Minor Project Review

14-035MPR – BSC Commercial District

Shoppes at River Ridge – River's Edge Pediatrics – Sign – 4335 West Dublin-Granville Road

date 24 April 2014
project number DUB1206
project name City Of Dublin, Ohio
Sign Submittal Review
applicant River's Edge Pediatrics

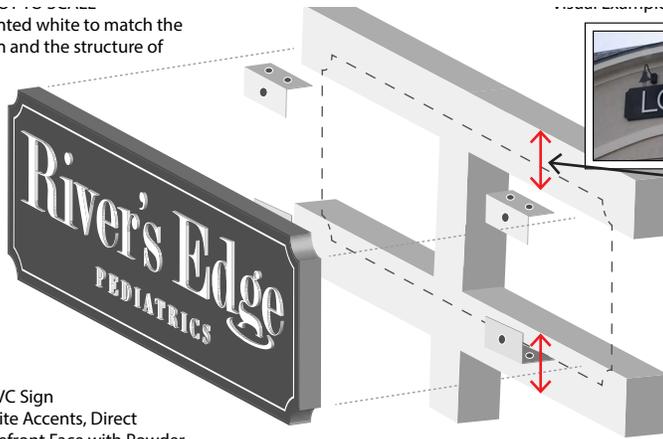
The vertical dimension of this soffit is too small to allow for the sign face to overlap and for the light fixture escutcheon.

Consider placement of the sign within one of the facade "frames" and over the primary entrance.

This dimension is critical to know in conjunction with the sign overlap and light fixture escutcheon. Based on estimates, the space is not enough to accommodate the sign overlap and the light fixture.

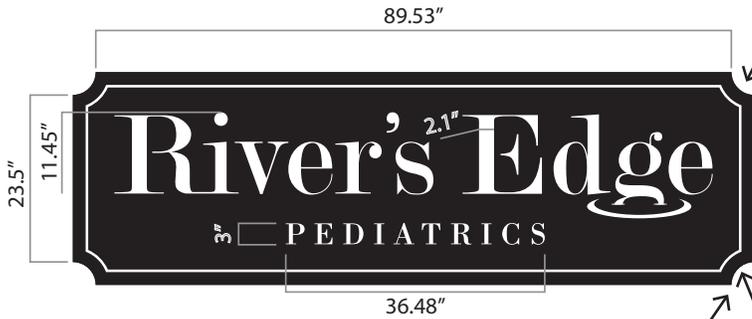
The sign frame would reinforce the business brand identity if it matched the logo artwork (copied from website and Facebook site below).
